Possible Oil Reservoir Cap Leak

All IS1500Z Models

101-948

**Work Performed:** Repaired per Service Bulletin F075

**Figure 1. Oil Reservoir**

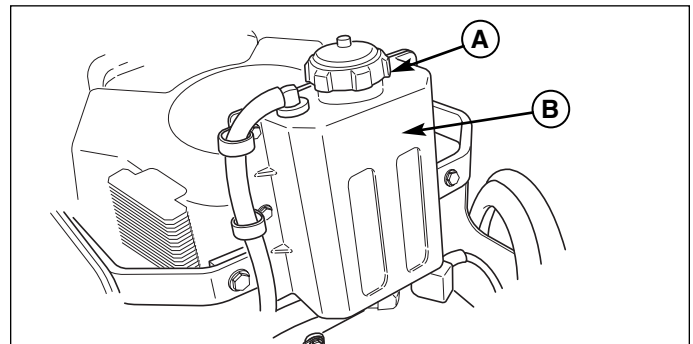
Early production IS1500Z Series zero-turn riders were built with oil reservoir caps that may leak. New caps (part number 5100017) are available, and will be shipped to you automatically, **at no charge**.

Only units in the listed serial number range are affected by this update due to an interference between the reservoir and the original cap. Product above the serial number range has had the interference corrected.

Please replace the caps on all units in your inventory and all retailed units that fall within the serial number range.
